Access Compliance Report

Public Rights-of-Way

(Curb Ramps)

Intersection ID: 19251	Main Street: CHERRY_TRIPP_DR	Cross Street: VILLAGE_LAKE_DR	Location: SW
ADA ID: 03AEFFE8EF40	Ramp Type: PerpDiag	Initial Pass/Fail: Fail	Overall Compliance: No
Codes/Mitigation Info/Possible Solution		Field Measurements/Component Compliance	
Severity Score: 26.25

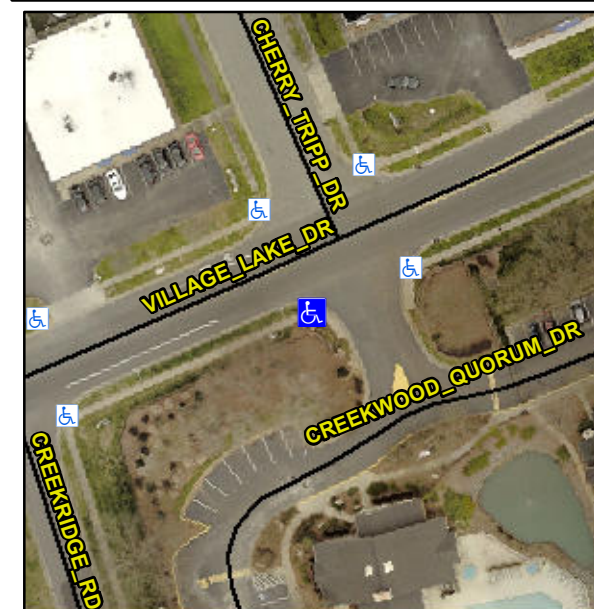
Remove & Replace Curb Ramp With Two New Directional Ramps or Equivalent.

R304.2.2, R304.5.3
